## **ARTICLE 14. ONE AND TWO FAMILY DWELLING CODE**

### **Rule 2.1. CABO One and Two Family Dwelling Code; Amendments**

**FIGURE R502.8  
CUTTING, NOTCHING AND DRILLING**

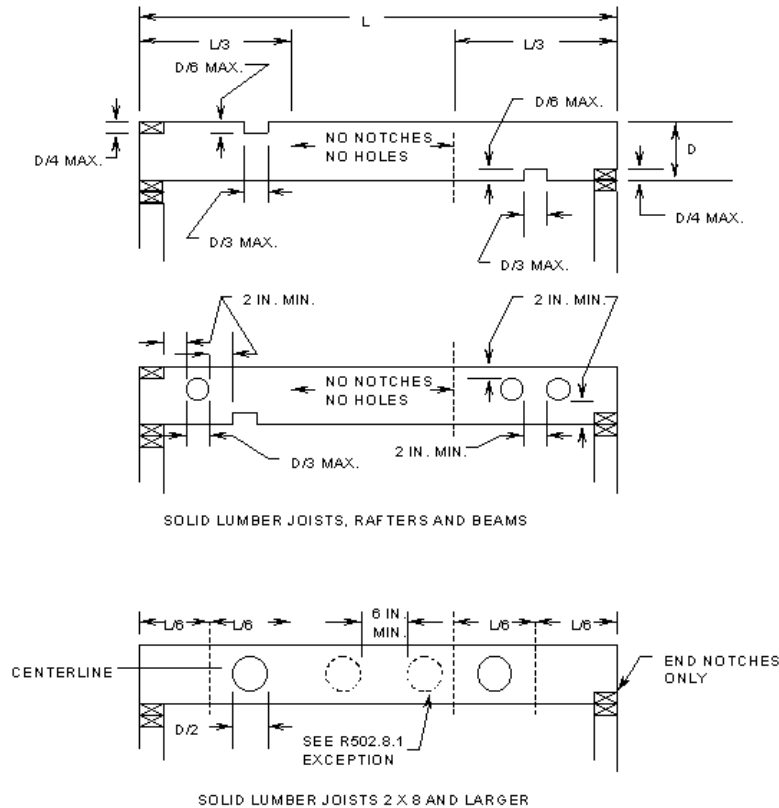
Sec. 88. Delete FIGURE R502.8 and substitute as follows: FIGURE R502.8:

FIGURE R602.6(2)  
NOTCHING AND BORED HOLE LIMITATIONS FOR INTERIOR NONBEARING WALLS

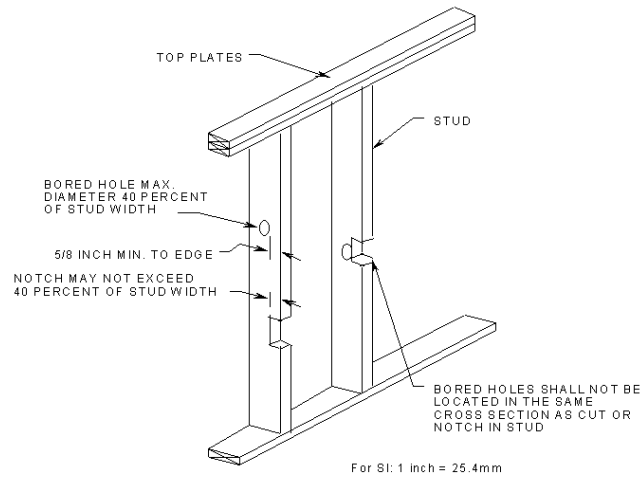
Sec. 95. Delete FIGURE R602.6(2) and insert FIGURE R602.6(2) to read as follows:

**FIGURE R602.10.5(2)**  
**GARAGE DOOR BRACED WALL PANEL FOR USE WITH CONTINUOUSLY SHEATHED WALLS**

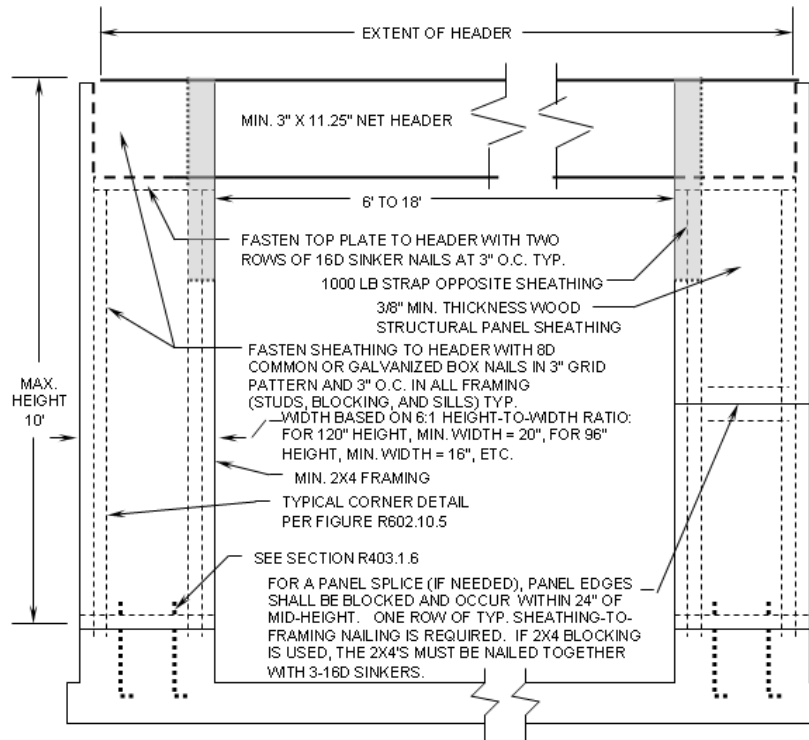
(3) Add an exception to read as follows: Exception: Vertical wall segments in the first of one or first of two story buildings next to garage openings shall be permitted to have 6:1 height-to-width ratio (with height being measured from top of header to sill plate) when constructed in accordance with the following provisions. Each panel shall have a length of not less than 16 inches (406 mm) and a height of not more than 10 feet (3,048 mm). Each panel shall be sheathed on one face with a single layer of 3/8 inch minimum thickness (9.5 mm) wood structural panel sheathing nailed with 8d common or galvanized box nails in accordance with Figure R602.10.5(2). The wood structural panel sheathing shall extend up over the solid sawn or glued-laminated header and shall be nailed in accordance with Figure R602.10.5(2). The header shall extend between the inside faces of the first full-length outer studs of each panel. The clear span of the header between the inner studs of each panel shall be not less than 6 feet (1,829 mm) and not more than 18 feet (5,486 mm) in length. A strap with an uplift capacity of not less than 1,000 pounds (454 kg) shall fasten the header to the side of the inner studs opposite the sheathing. Two anchor bolts shall be installed in accordance with Section R403.1.6, and plate washers shall be a minimum of 2 inches by 2 inches by 3/16 inch (51 mm by 51 mm by 4.8 mm) thick and shall be used on each bolt. This exception is only permitted in Seismic Design Categories A-C.

(4) Add FIGURE R602.10.5(2) to read as follows:

FIGURE R703.7.6(1)

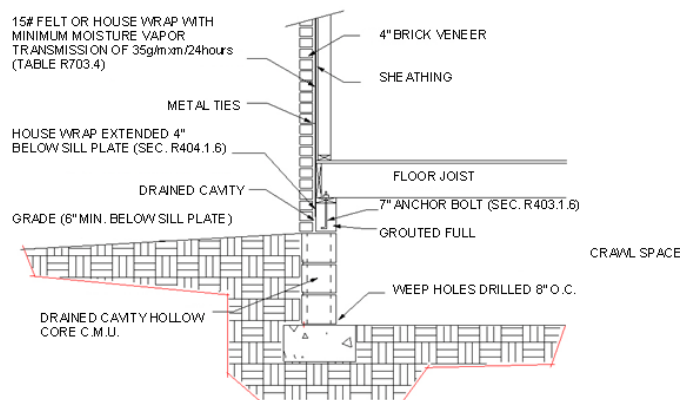
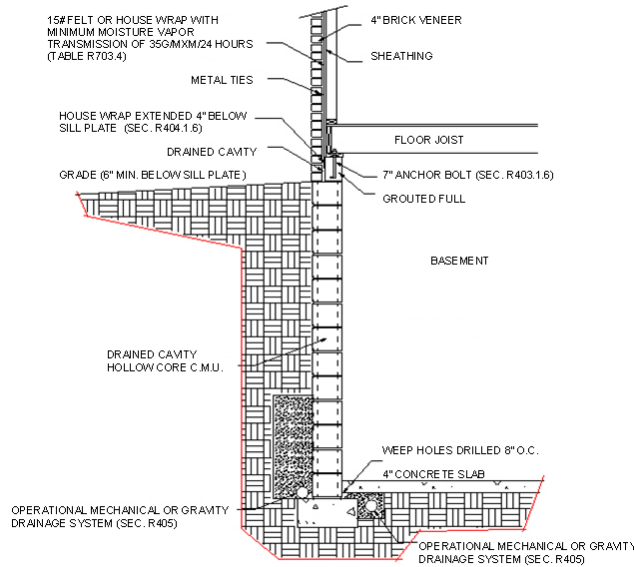
Sec. 121. Delete the title and text of SECTION R703.7.6 and substitute as follows: R703.7.6 Drained cavity. The 3/4 inch (19 mm) air cavity shall be drained to the exterior of the structure at intervals of not more than 33 inches (838 mm) on center. Each drain shall be not less than 3/16 inch (4.8 mm) in diameter, located immediately above the flashing. For dwellings with crawl spaces, the air cavity may be drained as shown in FIGURE R703.7.6(1). For dwellings with basements, the air cavity may be drained as shown in FIGURE R703.7.6(2).

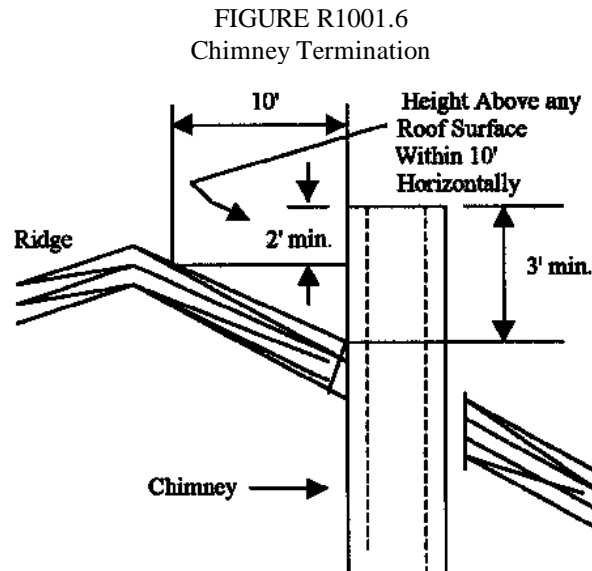
Sec. 135. Add FIGURE R1001.6 as follows:

**FIGURE E3801.4.1**

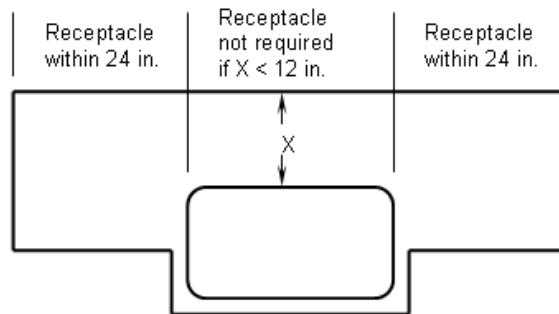
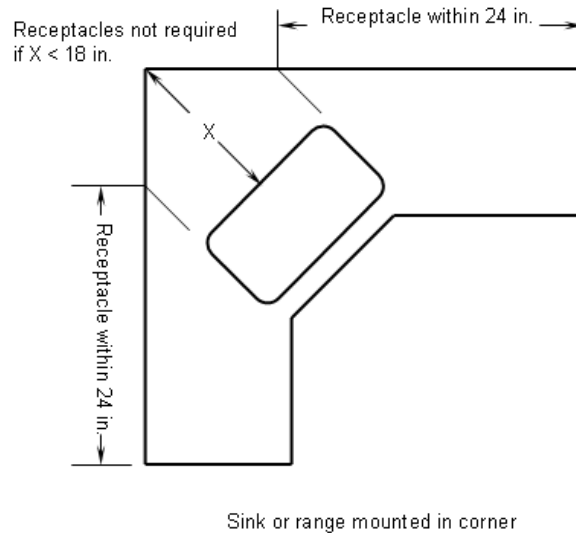
Sec. 229.5. (a) After SECTION E3801.4.1, add an exception to read as follows: Exception: Receptacle outlets shall not be required on a wall directly behind a range or sink in the installation described in FIGURE E3801.4.1.

(b) After SECTION E3801.4.1, add FIGURE E3801.4.1 as follows:
